RE: Preliminary Adequacy Response (AM-05), Pueblo East, Permit No. M-1986-015

Following are our responses to the Division of Reclamation, Mining and Safety's (DRMS) comments on our Amendment Application, AM-05 for the Pueblo East Permit, Permit No. M1986-015.

Date: 09/FEB/21
Job No: 728
Drawn: LD
Design: DT
Checked:
File: Exhibit B-1
Scale: 1" = 4,000'

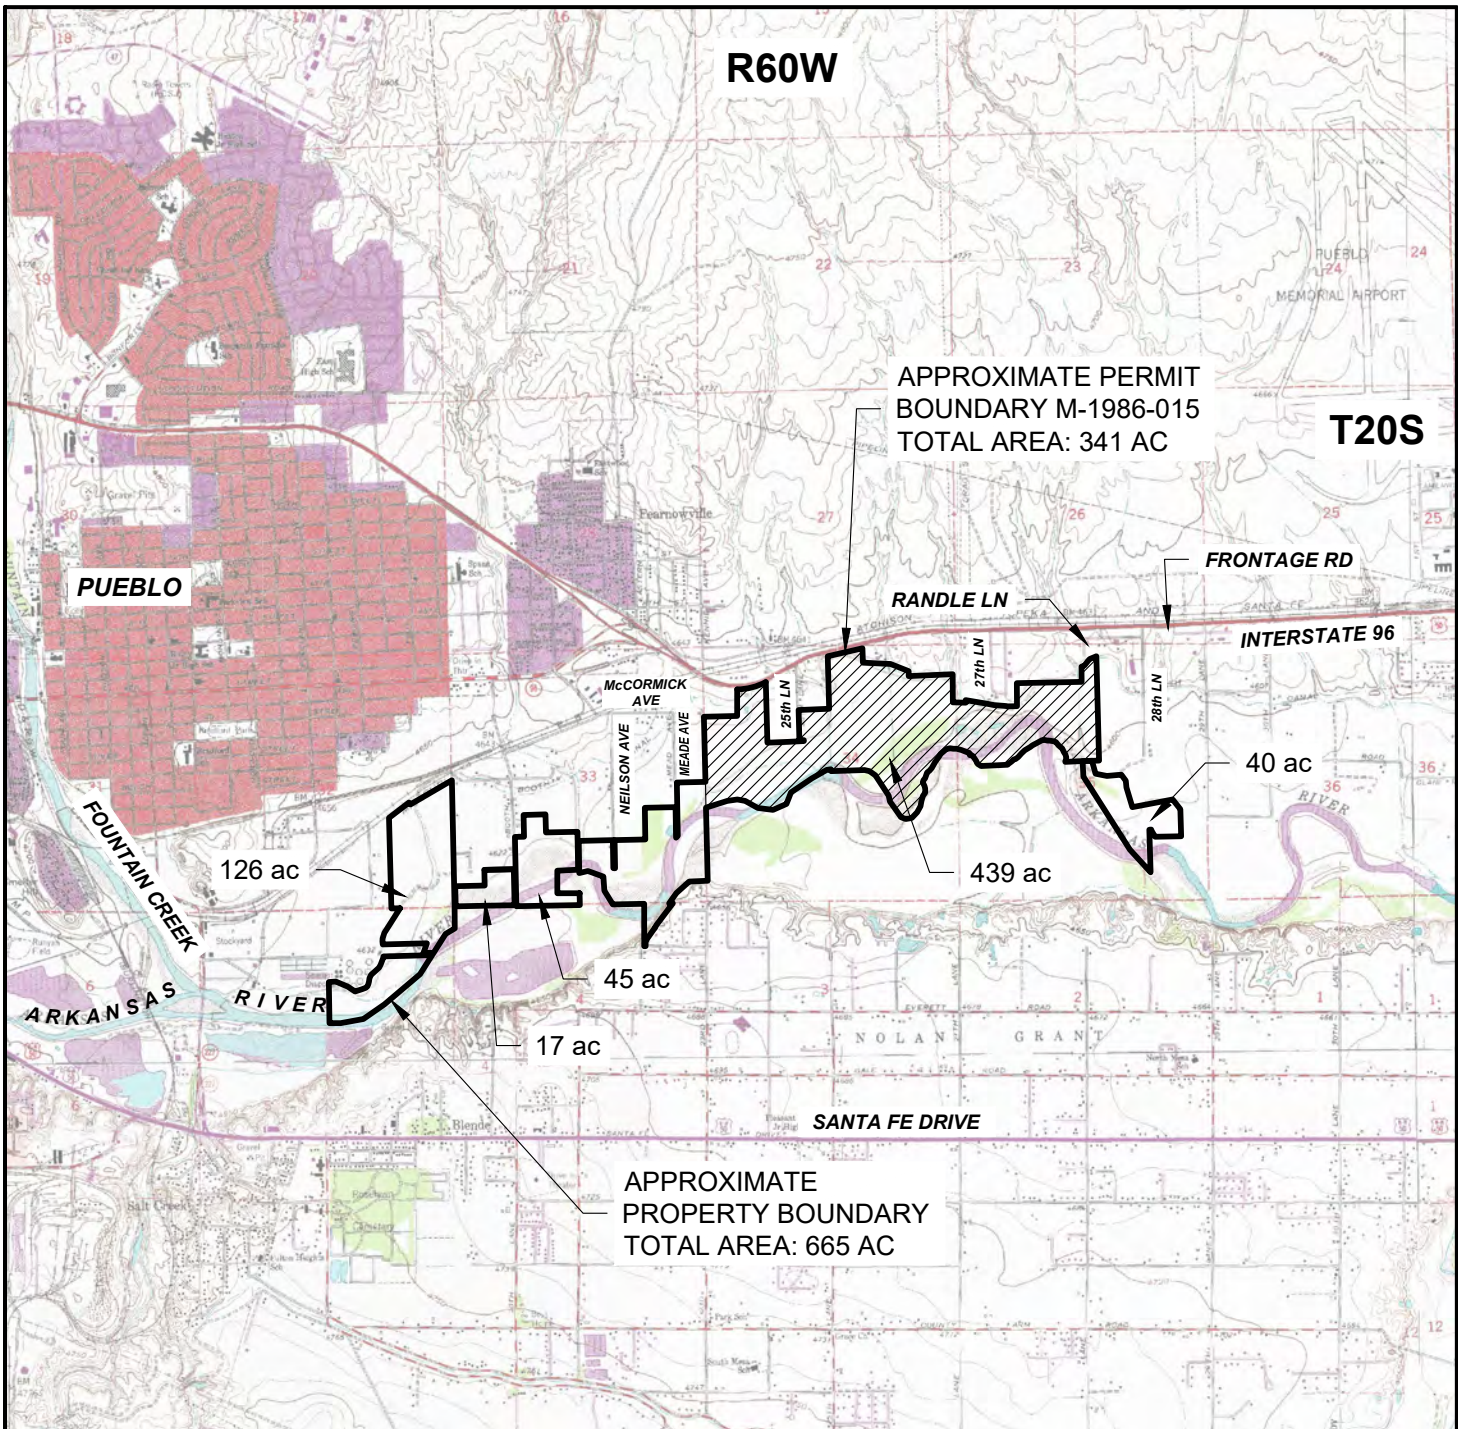
- 4. *Please provide an updated Index Map that depicts the current approved permit boundary along with acreage. The map provided depicts the cement plant being in the permit boundary.*
 - Response: Reference, Pueblo East Pits, Amendment 5, Index Map B-1

EXHIBIT C-1
PRE-MINING AND MINING PLAN

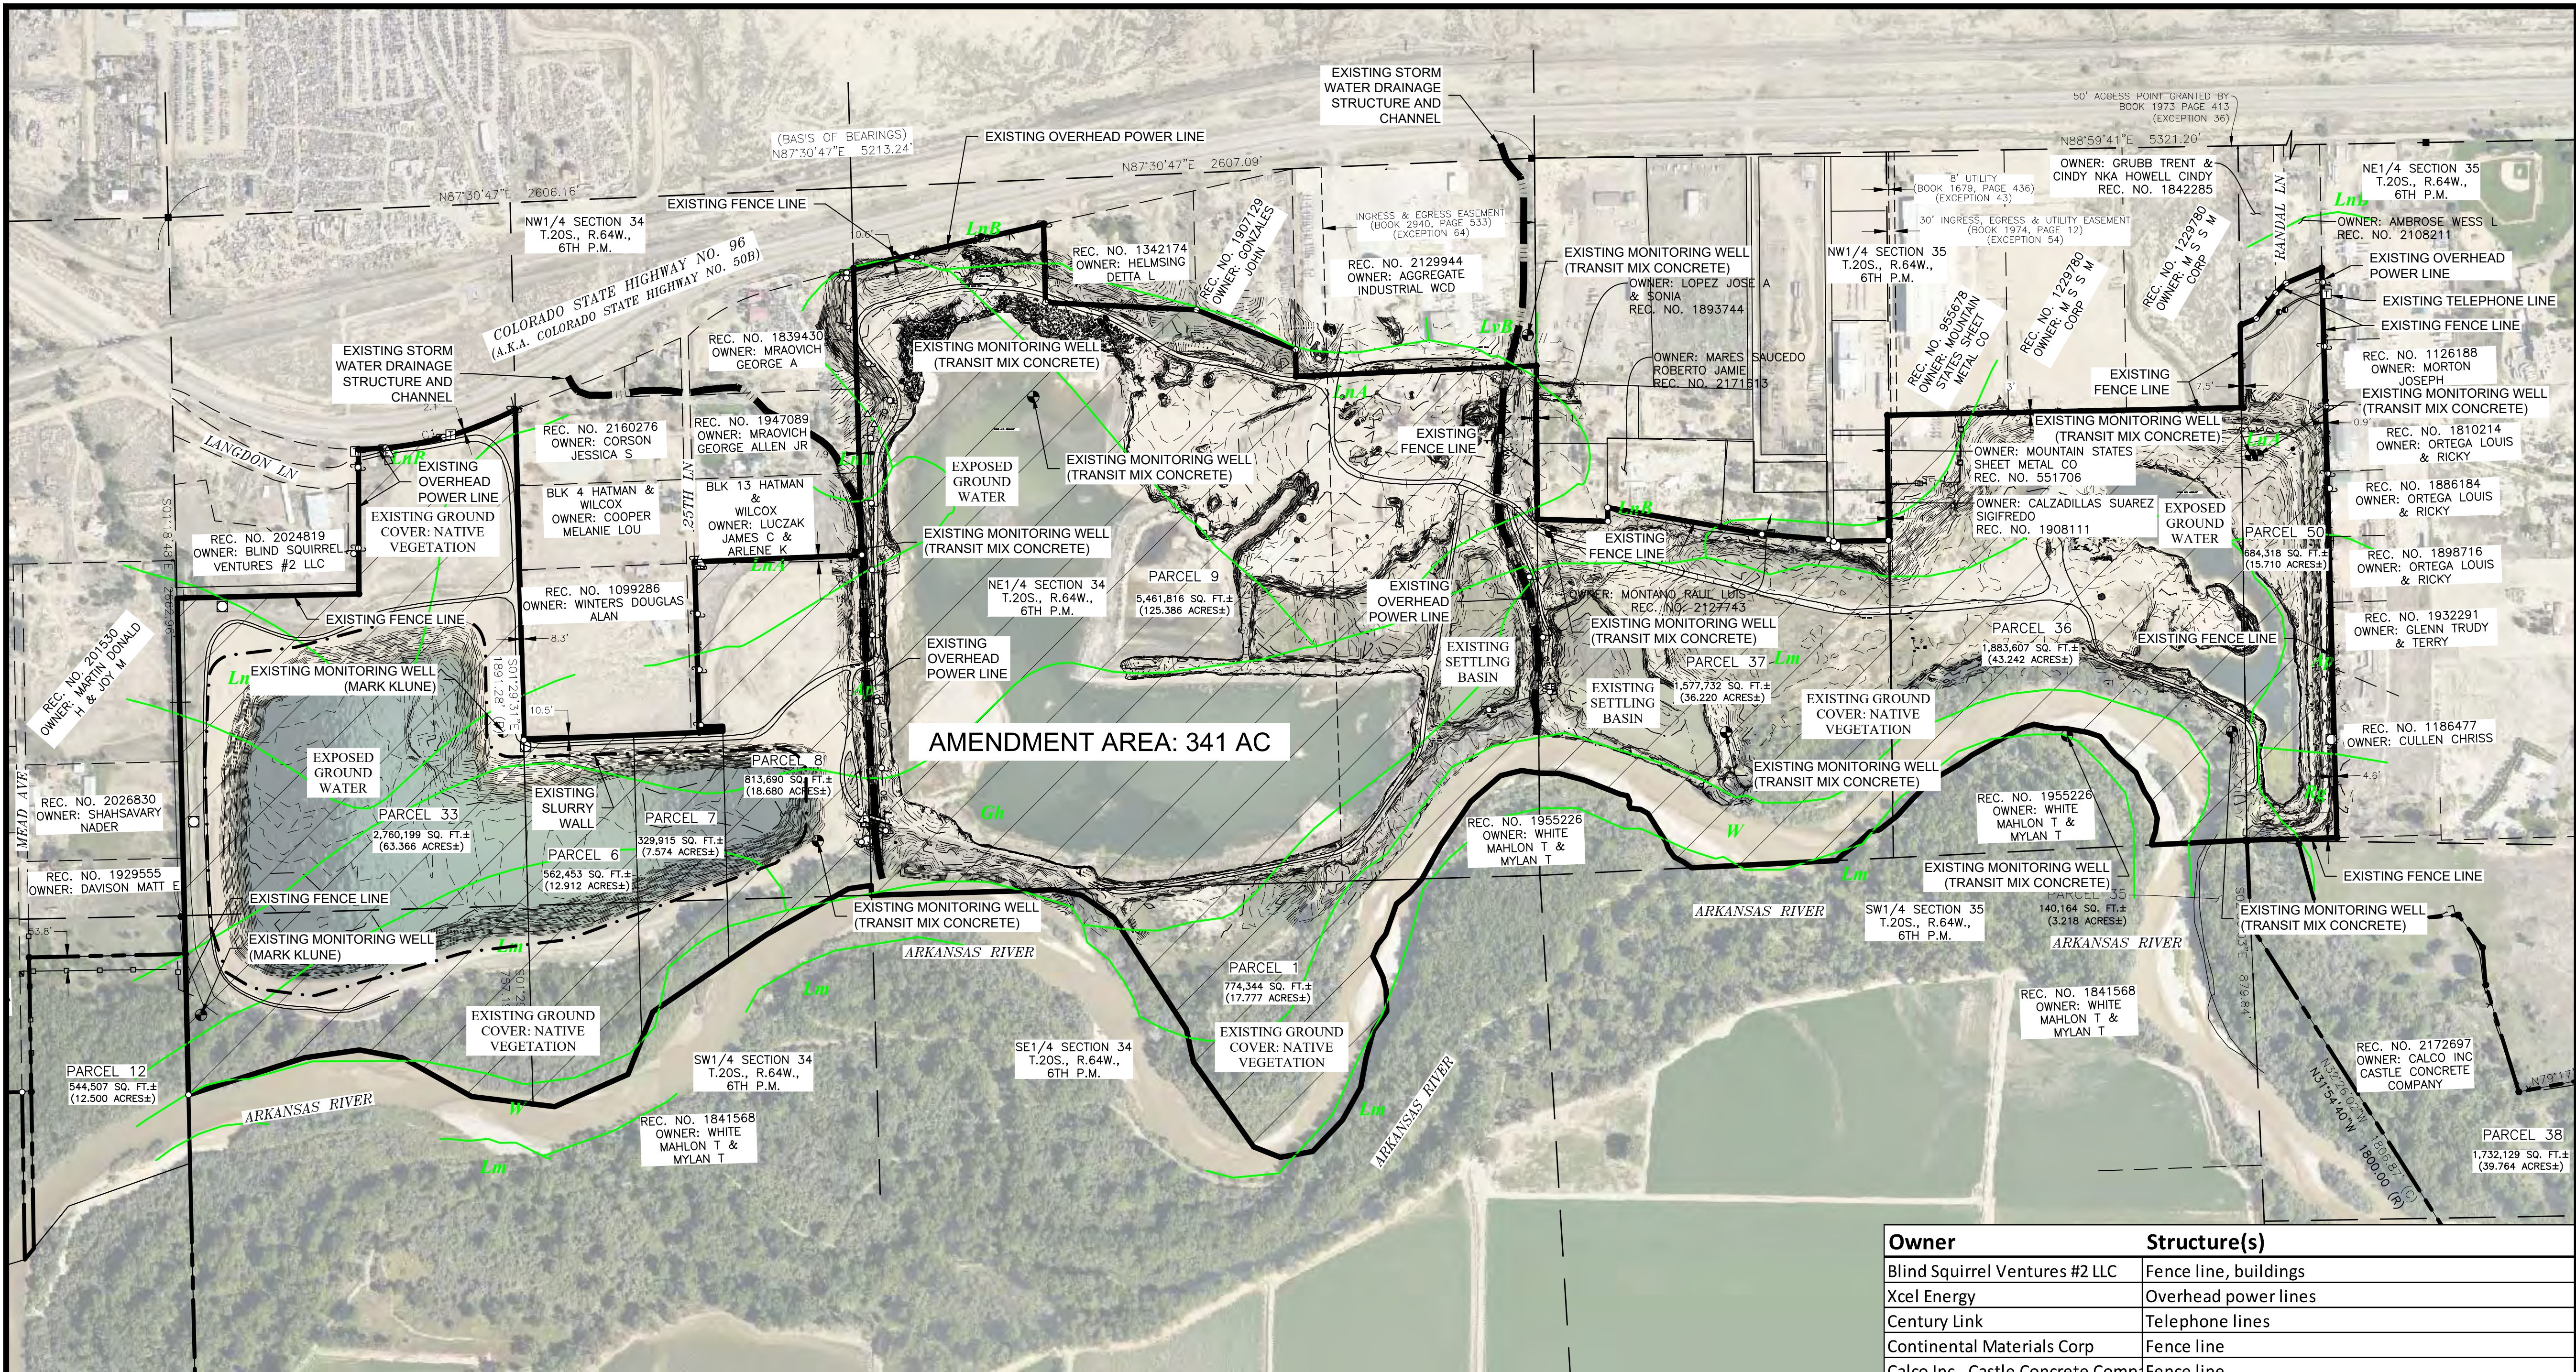
- 5. Please provide a map or maps, meeting the requirements specified in Rule 6.2.1(2), depicting the following:
 - all adjoining surface owners of record;
 - the name and location of all creeks, roads, buildings, oil and gas wells and lines, and power and communication lines on the area of affected land and within two hundred (200) feet of all boundaries of such area;

- *6. It appears that the operator may have provided some of these details in maps E-01 through E-04 but the maps do not meet all the requirements of Rule 6.2.1(2) and the Division could not determine where these maps are referenced in the amendment application.*

➤ Response: Reference, Pueblo East Pits, Amendment 5, Pre-mine, C-1
- The existing topography of the area with contour lines of sufficient detail to portray the direction and rate of slope of the affected land;

- Response:
 - ✓ We have revised the Maps E-01 through E-04 to include the information required by Rule 6.2.1(2). In addition, there is some requested information we request the DRMS waive given the nature of the site, i.e., soils, wildlife and vegetation, as discussed in this document.

- ✓ Please refer to Maps B-1 and C-1

EXHIBIT F-1
RECLAMATION PLAN

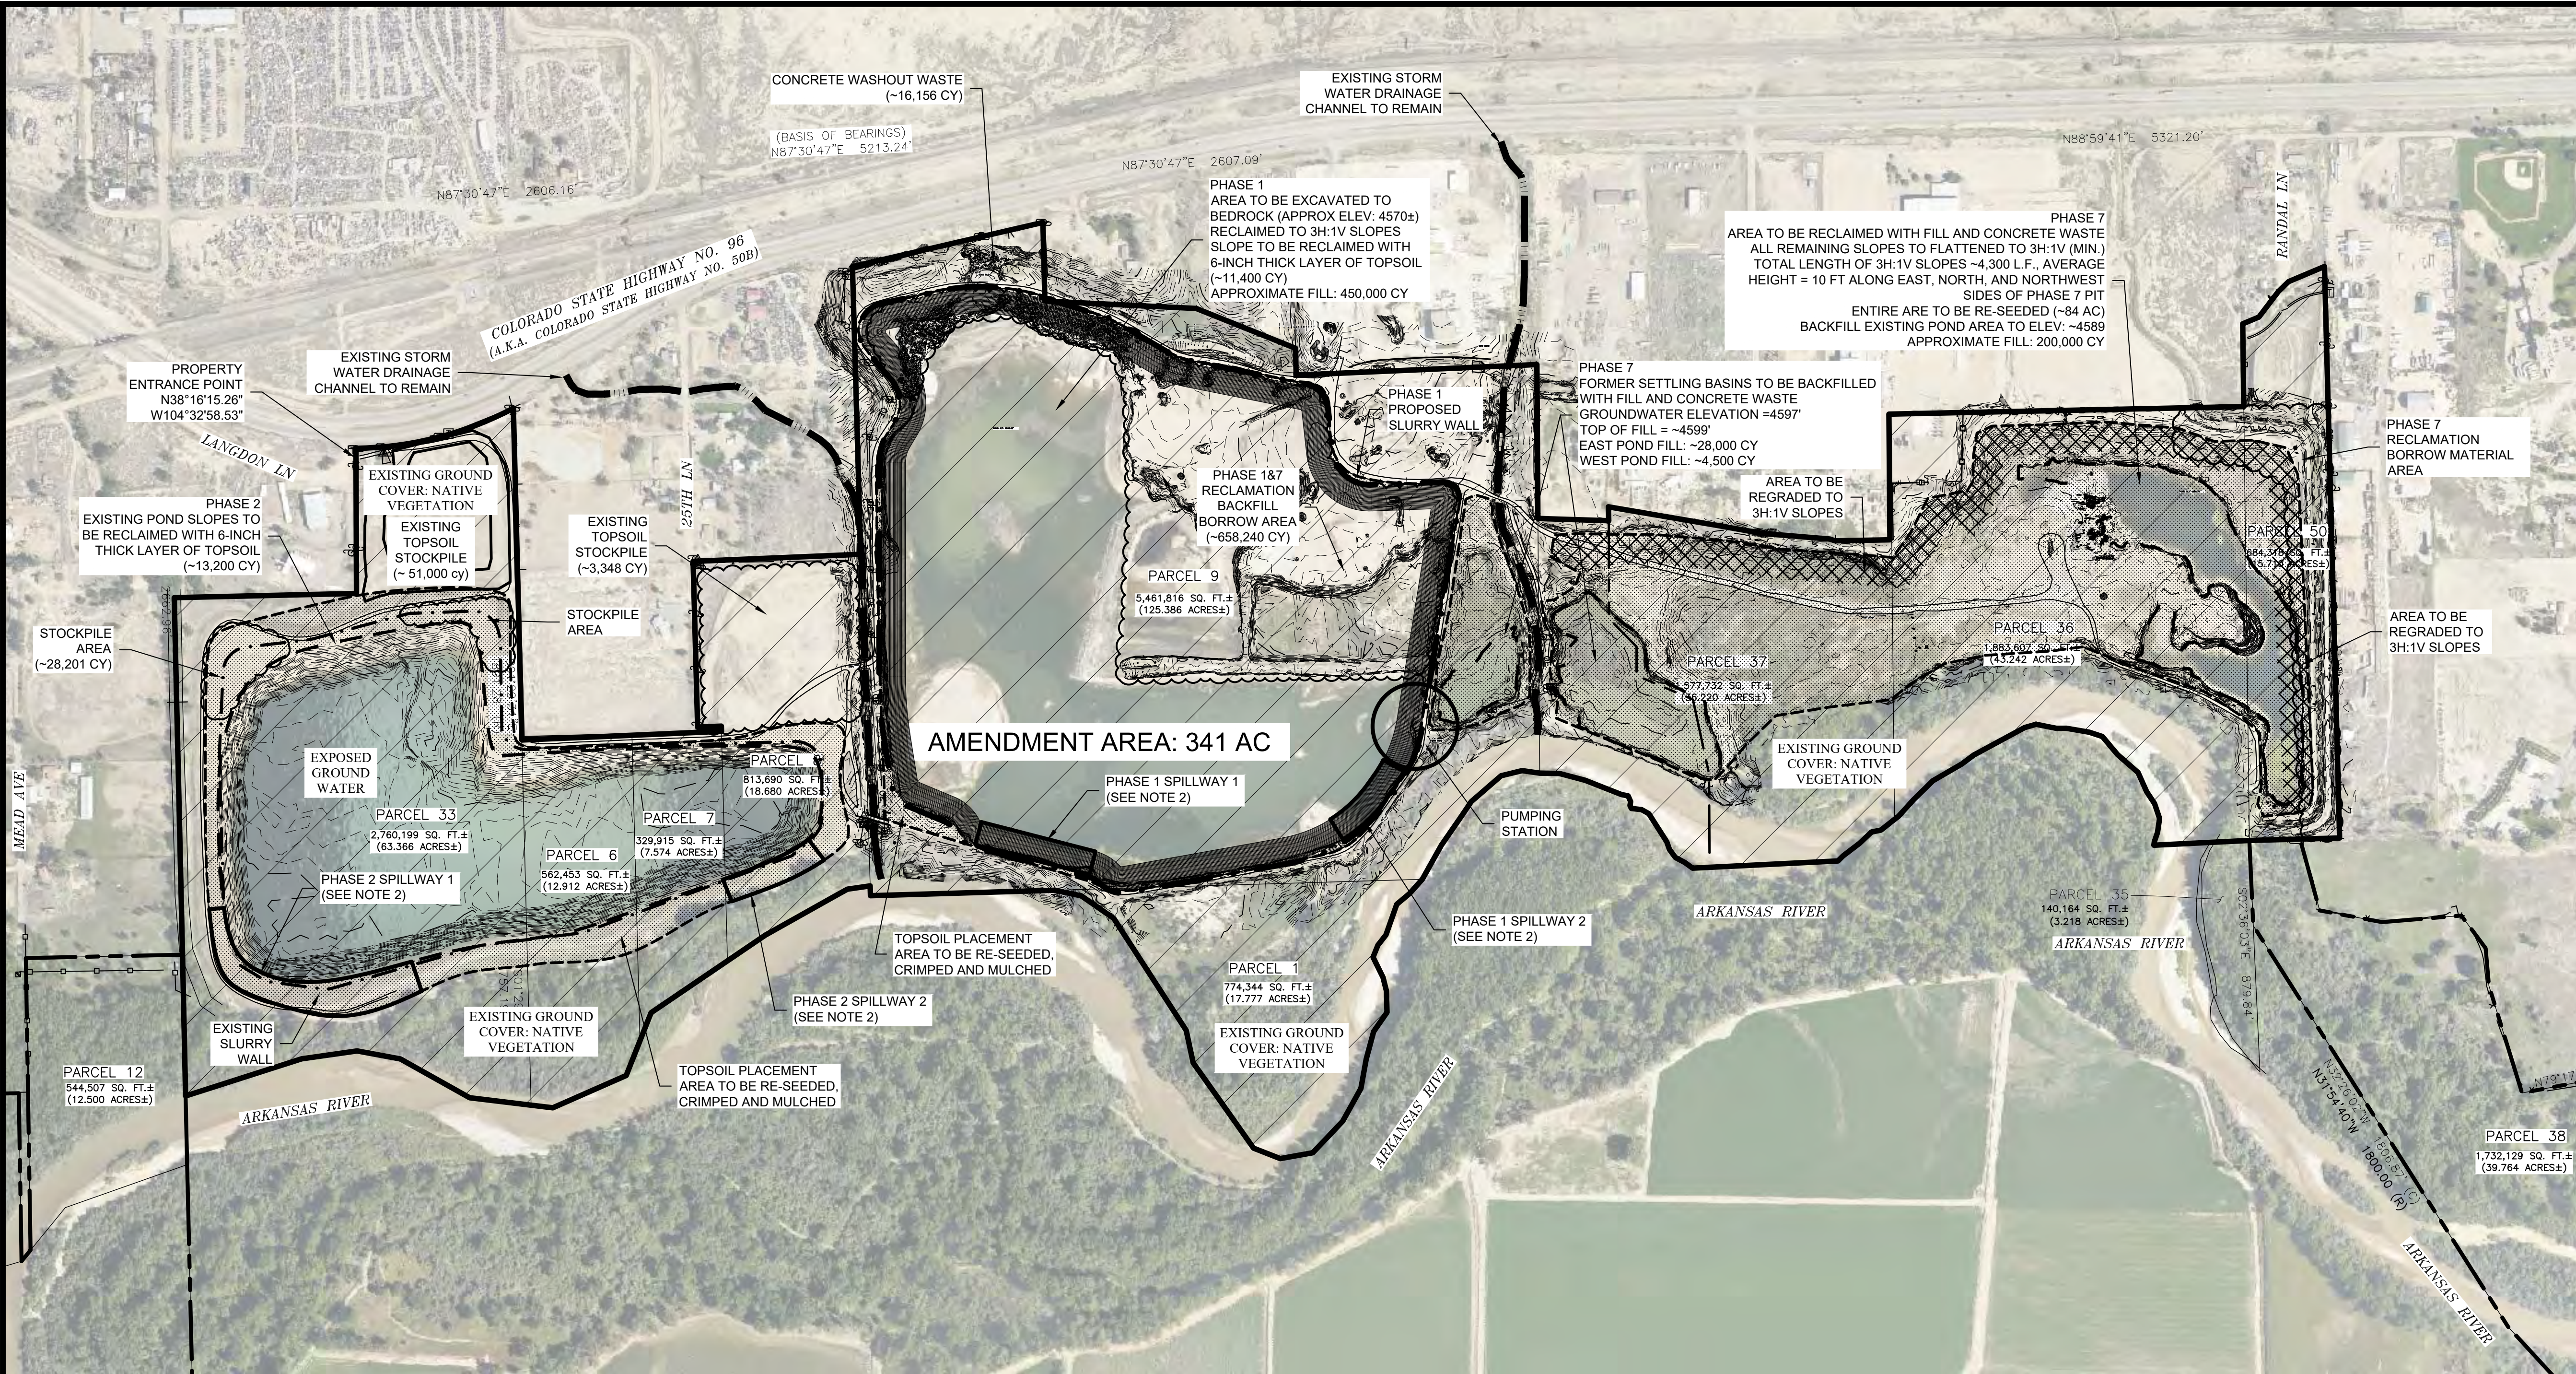
- *9. Phase 2 Area – Please clearly show on a map the areas that require grading and topsoil placement?*
 - Response:
 - ✓ Please see the revised Reclamation Plan Map F-1

- 18. Phase 1 Area – It is unclear what Drawing is being referenced in the description of the Phase 1 Area reclamation.
 - Response:
 - ✓ Please see Reclamation Plan new map F-1

- ✓ Any material not needed in Phase 1 will be used in Phase 7 after the slopes are completed.
- 20. *Phase 1 Area – Please address the need for an emergency outfall since the proposed pond is located within the 100-year floodplain. If an outfall is required please show its proposed location along with relevant details.*

- Response:
We understand no further action is needed.
- 39. *Phase 1 Cost Estimate – Please clearly show on the Reclamation Plan Map where the 12-acre area is located that the operator proposes to source the fill material for the pit slope reconstruction, it is not clear to the Division where this area is located on the map provided to other proposed Phase 1 items.*

- Response: Two outflow structures are shown on the Map F-1 to accommodate the location in the 100 year flood plain. Notes indicate the structures will be designed to accommodate site conditions for overflow. Those designs are not yet sized for the new configuration of the site.

- Response: Refer to Map F-1
 - ✓ The 12.3 acres as outlined by the blue line is the proposed barrow area.
